SERVICE BULLETIN

Service Bulletin No.: DAC1-34-02 Rev. 2

Title: Installation of backup Artificial Horizon Indicator

Figure 1

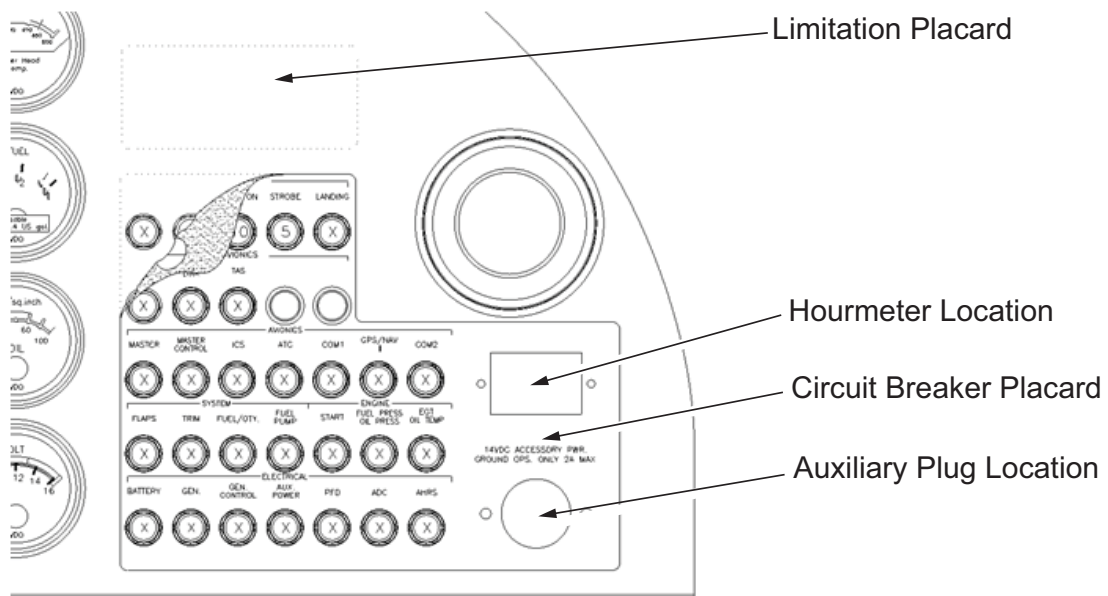
- 10.1 Disconnect the aircraft battery. Refer to AMM # DA201-C1, Chapter 24-31.
- 10.2 Remove the instrument panel cover. Refer to AMM # DA201-C1, Chapter 25-10.
- 10.3 Pull the battery circuit breaker located on the right side of the instrument panel.
- 10.4 Remove the auxiliary plug outlet and the hourmeter located on the right hand side of the instrument panel.
- 10.5 Remove the Limitations placard and Circuit Breaker placard and clean the placard areas with isopropyl alcohol. Refer to Figure 1.

Figure 2

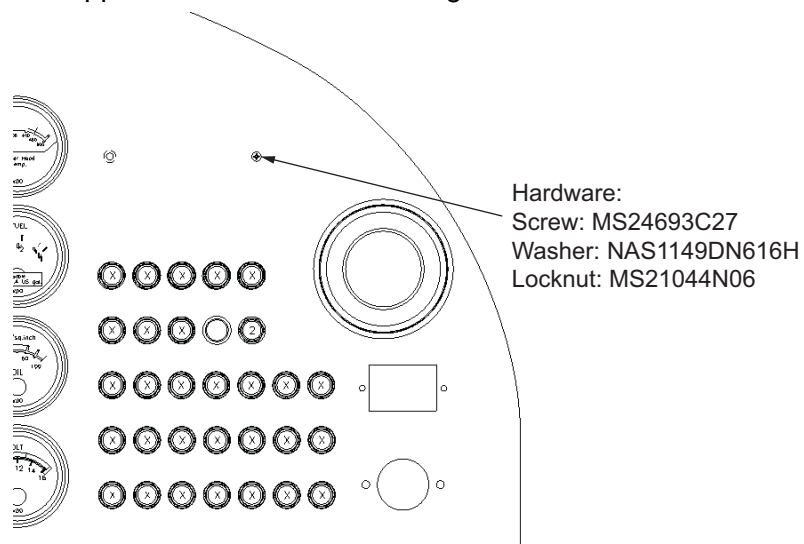
- 10.6.1 Remove the encoder from the instrument panel and plug the outboard hole with supplied hardware. Refer to Figure 2.

Figure 3

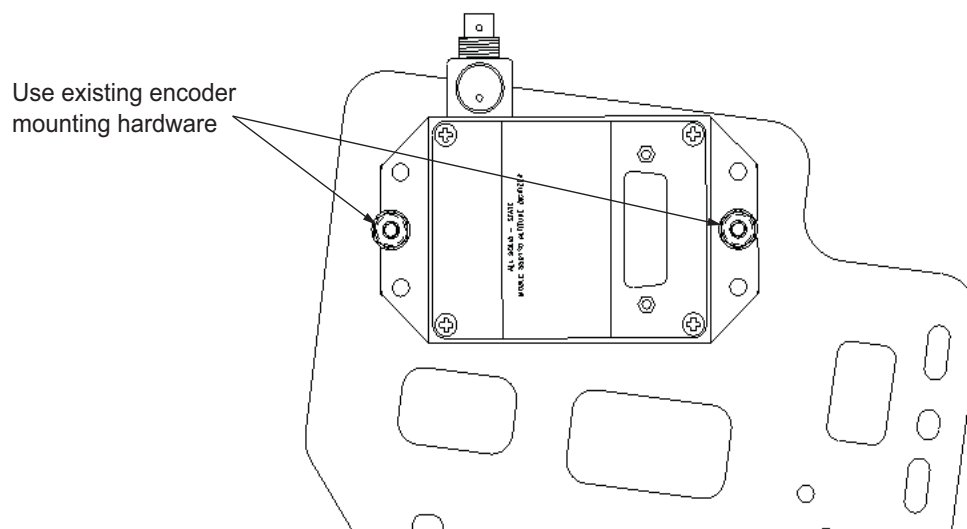
- 10.6.2 Install the encoder to the new support bracket (P/N 22-3412-80-00) using existing encoder mounting hardware. Refer to Figure 3.

Figure 4

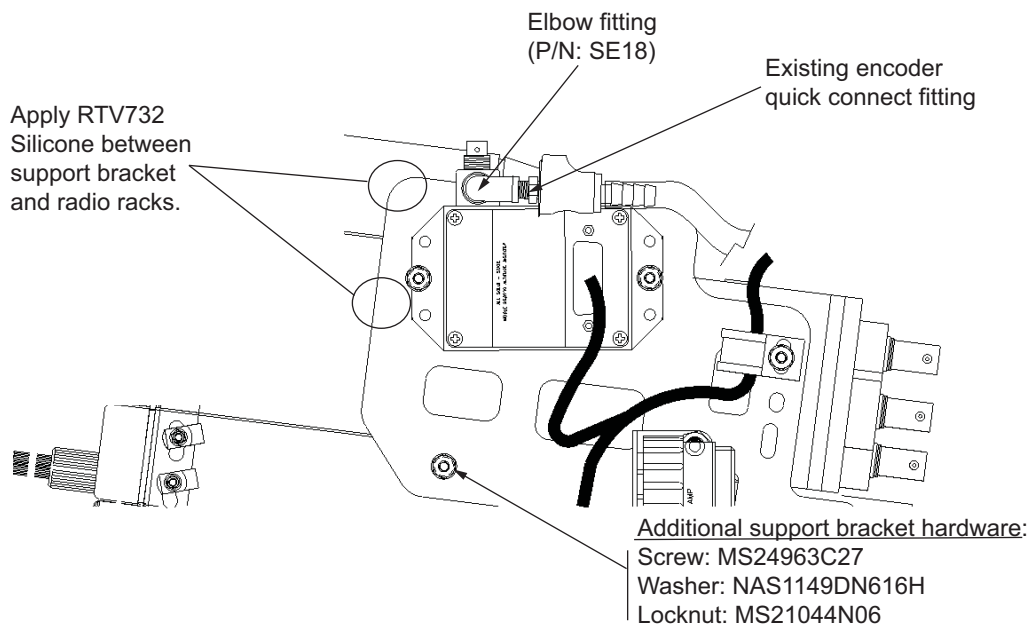
- 10.6.5 Remove the quick-connect fitting from the encoder and install the removed elbow fitting (P/N SE18) into the encoder and install the encoder quick connect fitting into the elbow fitting, as shown in Figure 4.

- 10.6.6 Apply RTV732 silicone (or equivalent) between the support bracket and radio rack. Refer to Figure 4.

- 10.6.7 Install the additional support bracket hardware as shown in Figure 4.

Figure 5

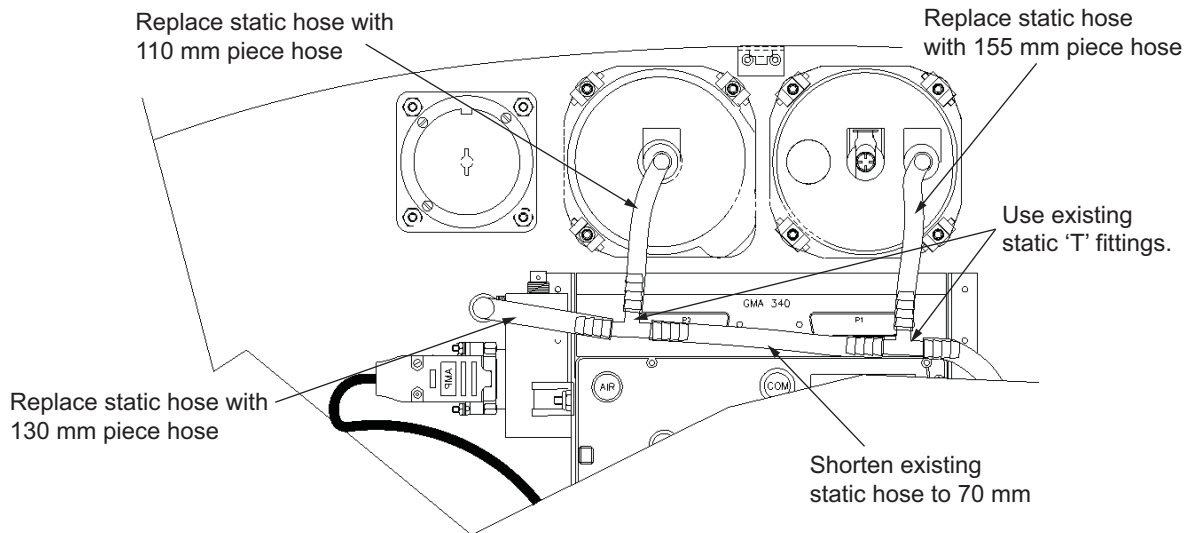
- 10.6.8 Replace the four static hose pieces with the supplied hose (P/N 210080) as shown. Ensure there are no low points in the static line. Refer to Figure 5.

Figure 6

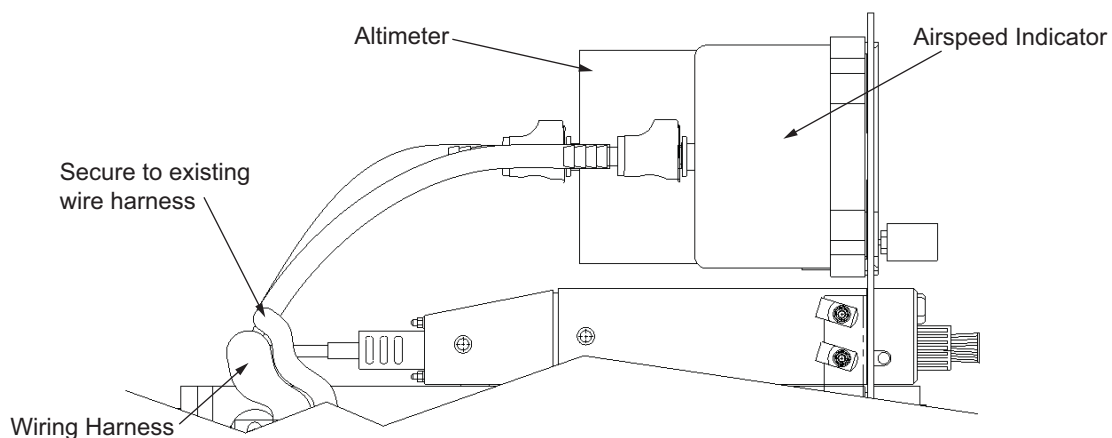
- 10.6.9 Secure hoses to the existing wire harness. Refer to Figure 6.

Figure 7

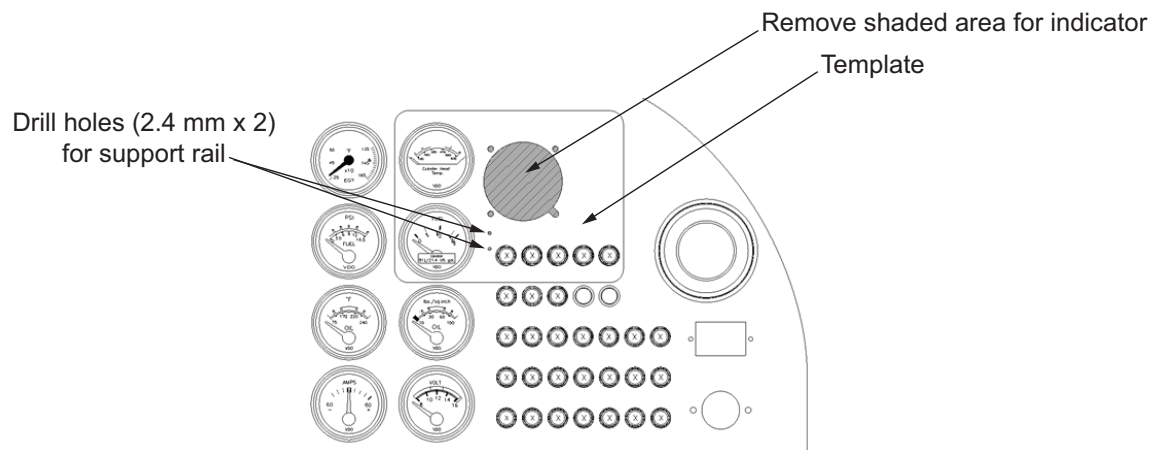
- 10.7 Use the Template provided in this SB to locate and drill holes for the artificial horizon and a support rail (2.4mm). Refer to Figure 7.

Figure 8

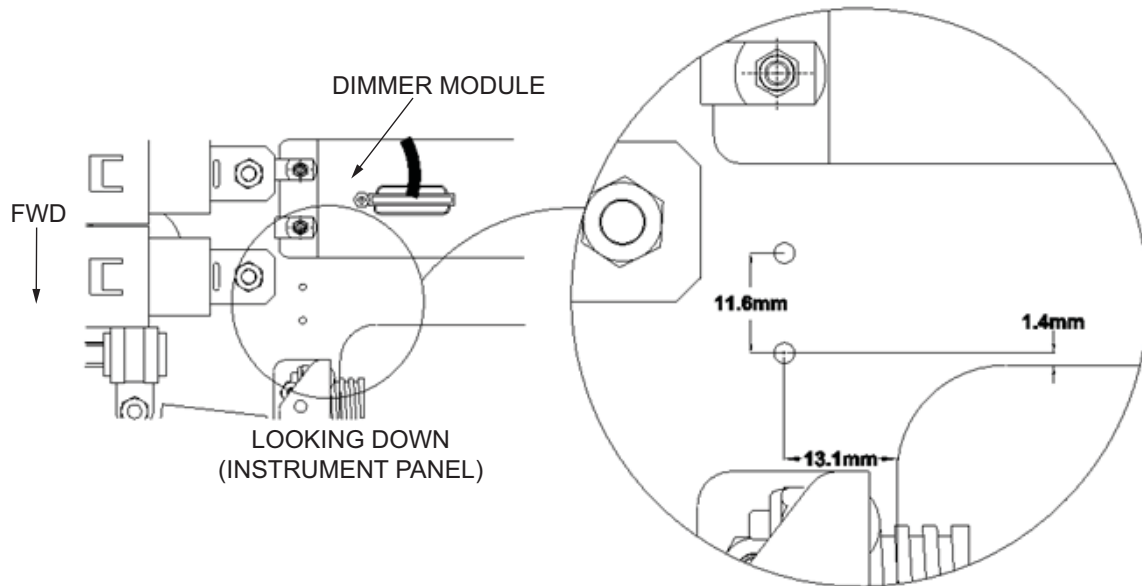
- 10.9 Drill two 2.4 mm diameter holes on the instrument panel bottom shelf. Refer to Figure 8.

Figure 9

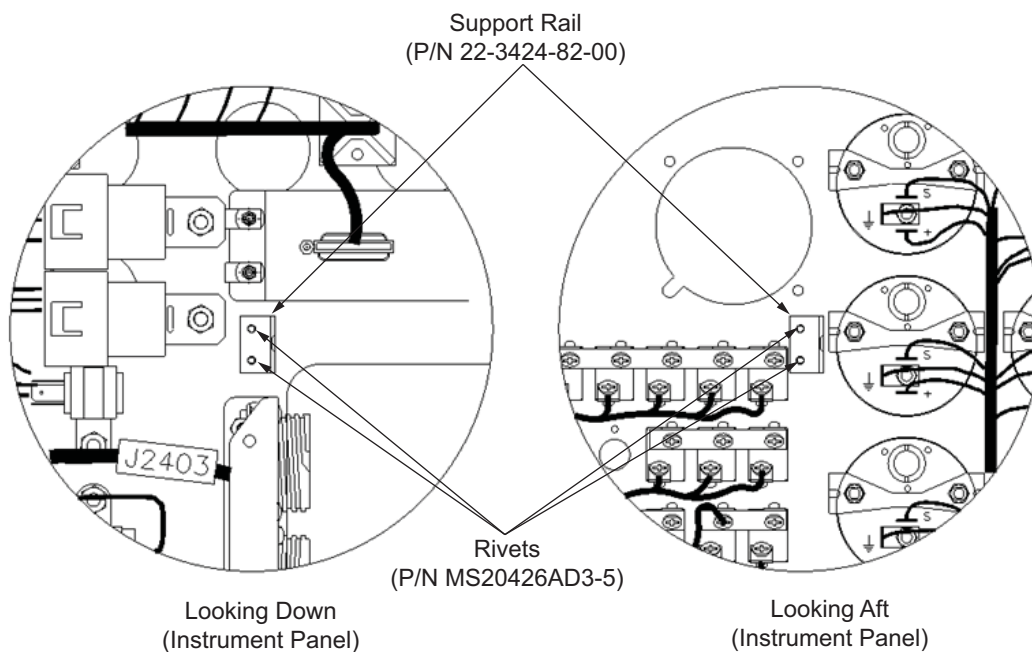
- 10.12 Rivet the support rails (P/N 22-3424-82-00) as shown in Figure 9 using supplied rivets (P/N MS20426AD3-5).

NOTE: Observe orientation of support rail as shown in Figure 9 when installing.

Figure 10

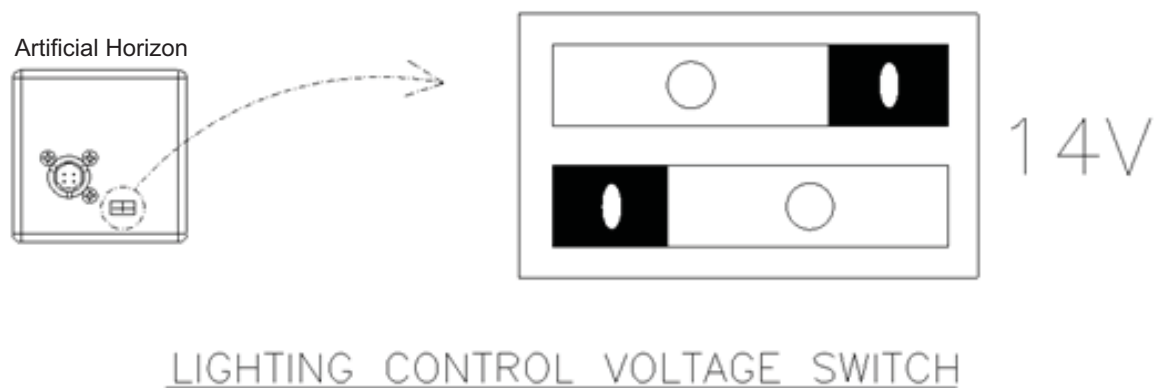
- 10.13 Prior to installing the Artificial Horizon, set the voltage control lighting switch to 14V. Refer to Figure 10.

Figure 11

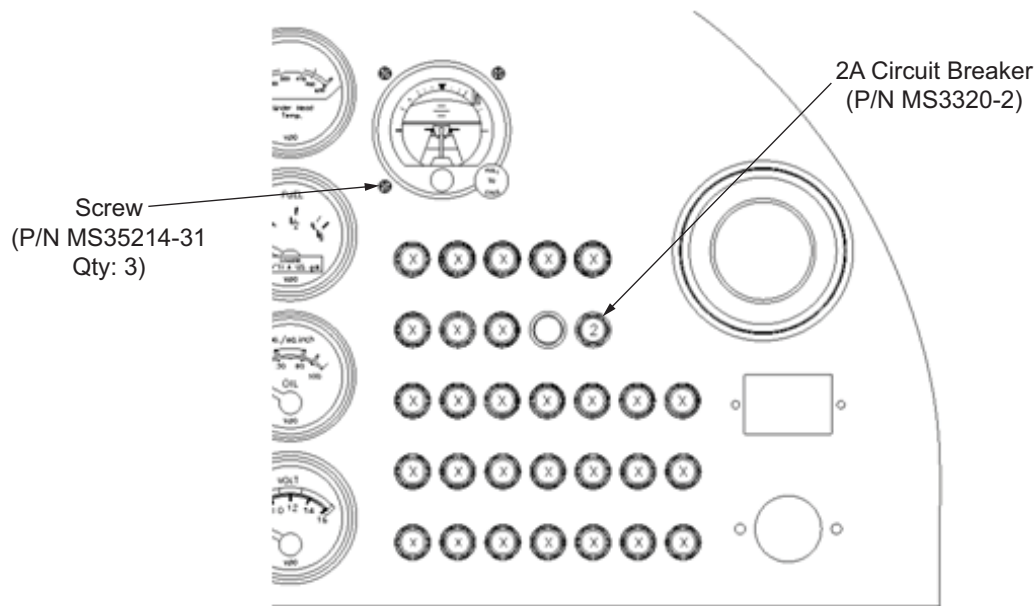
- 10.15 Install 2A circuit breaker (P/N MS3320-2) into the location shown in Figure 11.

Figure 12

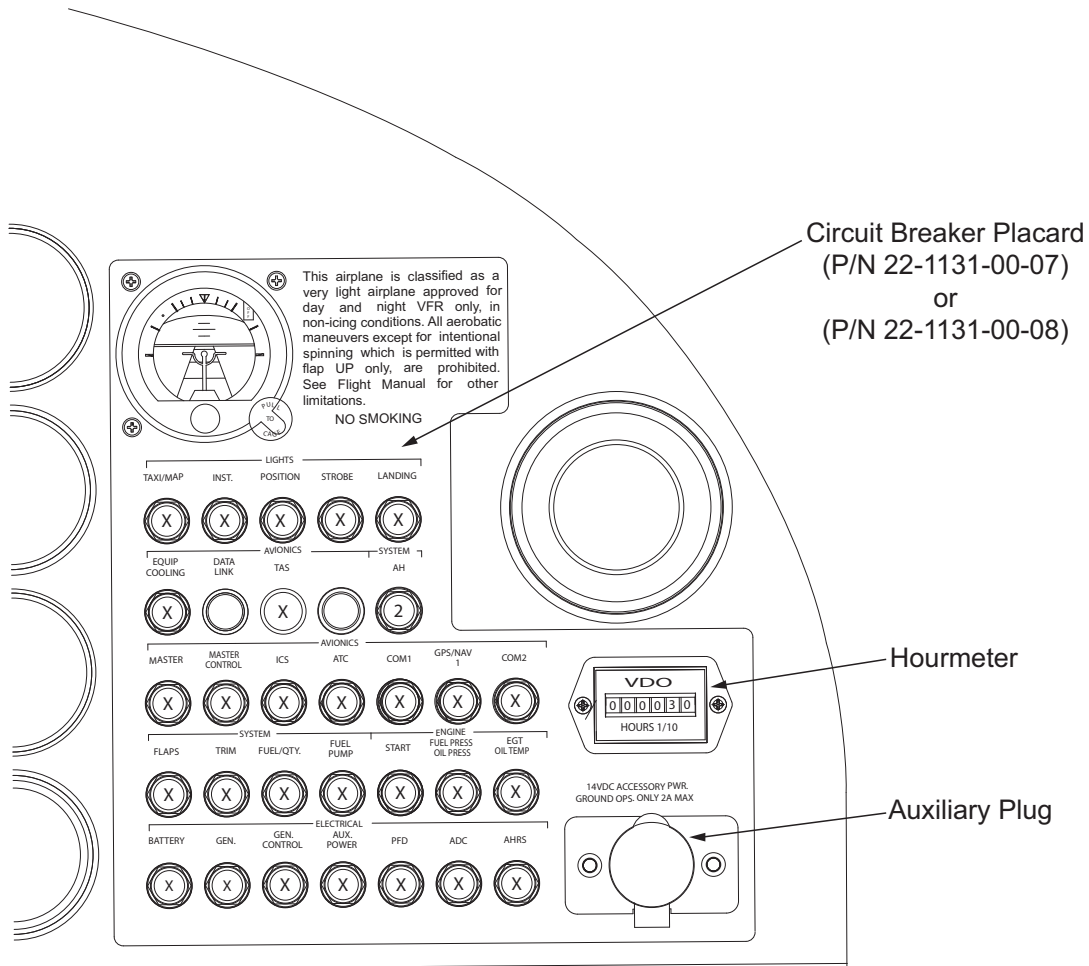
- 10.16 Install the new Circuit Breaker placard P/N 22-1131-00-07 for EASA or P/N 22-1131-00-08 for non-EASA member countries.
- 10.17 Install the hourmeter and the auxiliary plug outlet using existing hardware. Refer to Figure 12.

Figure 13

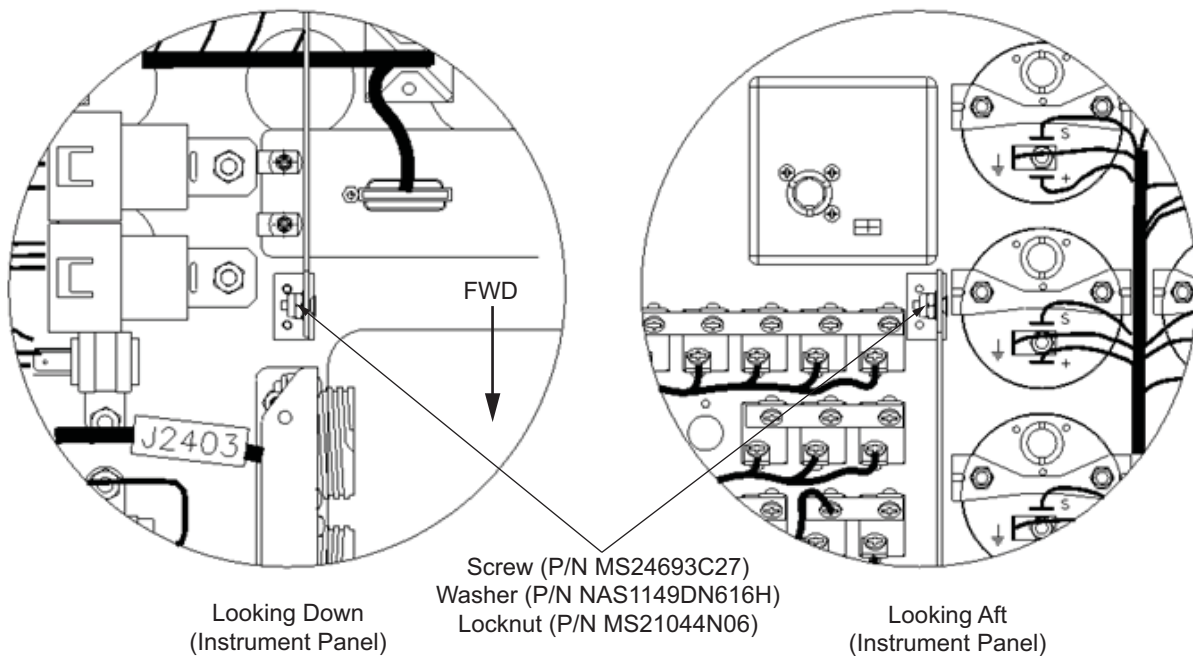
- 10.18 Install the support bracket (P/N 22-3424-81-00) using the screw (P/N MS24693C27), washer (P/N NAS1149DN616H) and the locknut (P/N MS21044N06). Refer to Figure 13.

Figure 14

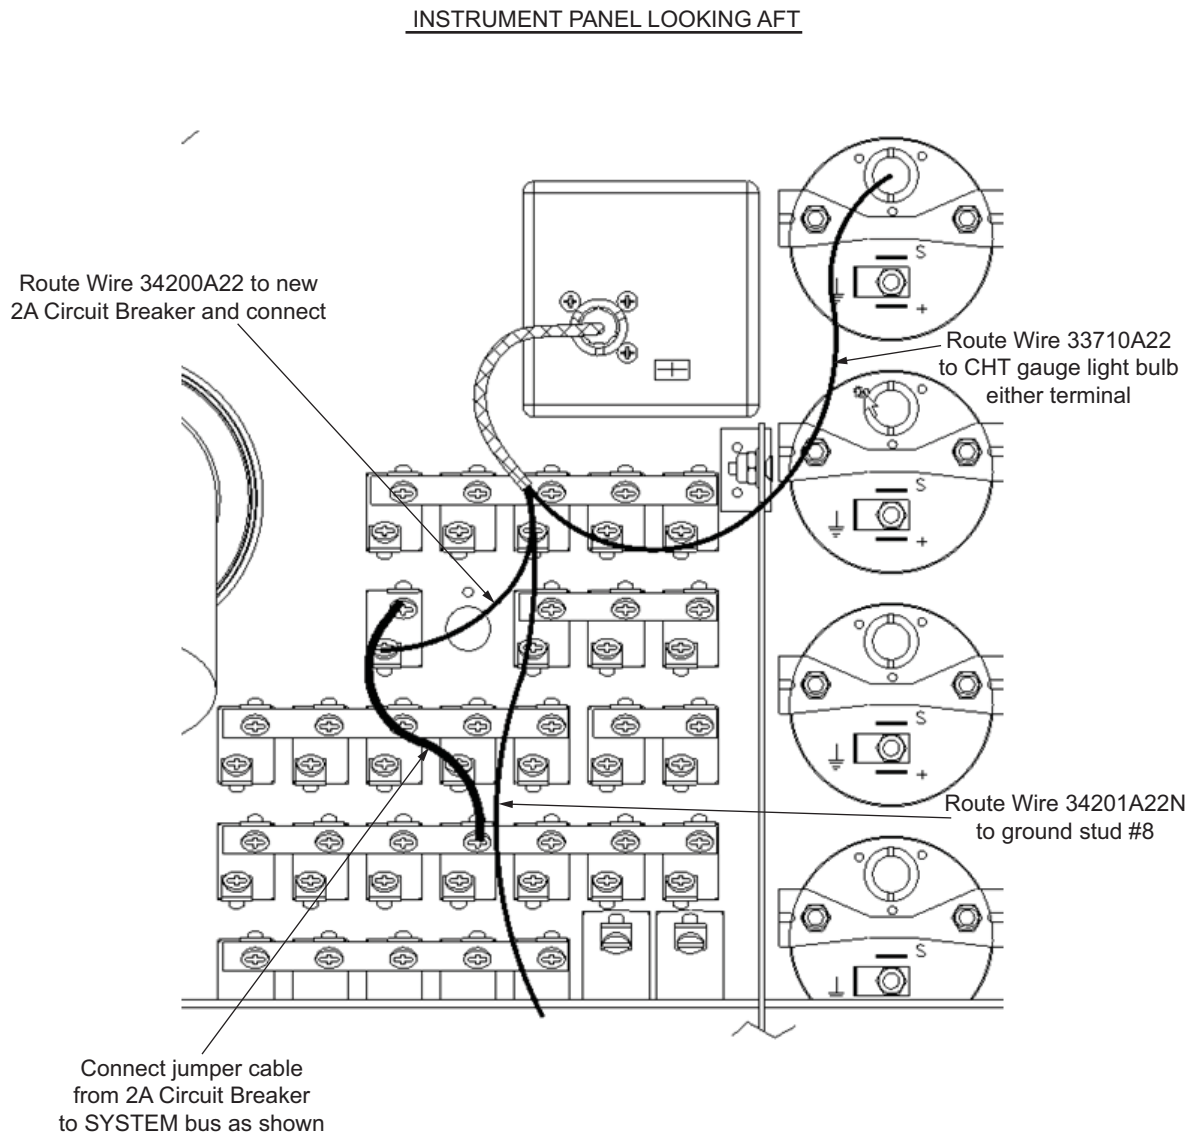
- 10.19 Install the Artificial Horizon harness (P/N 22-3424-01-00) and the supplied jumper cable. Refer to Figure 14 for details.

Figure 15

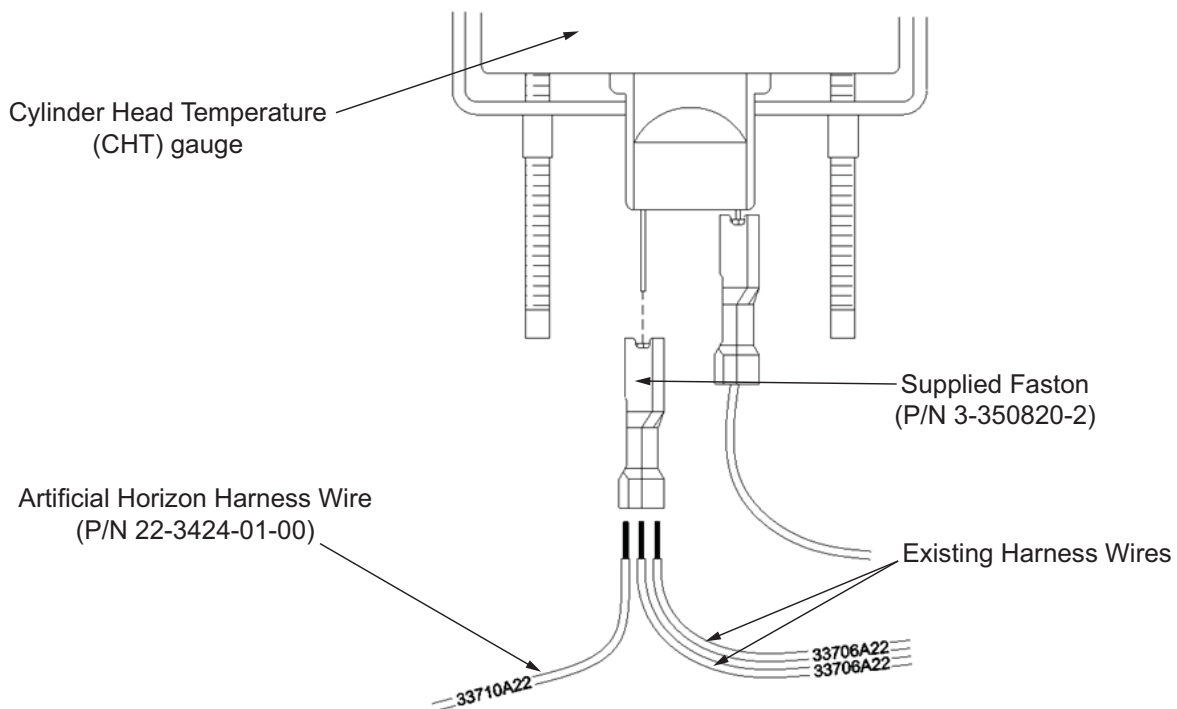
- 10.20 Cut off the existing faston contact from the Cylinder Head Temperature (CHT) gauge lighting wires (33706A22). Crimp 33710A22 wire with the existing CHT gauge lighting wires using the supplied faston contact. Refer to Figure 15.

NOTE: The wire code 33706A22 may be located on the other bulb terminal.
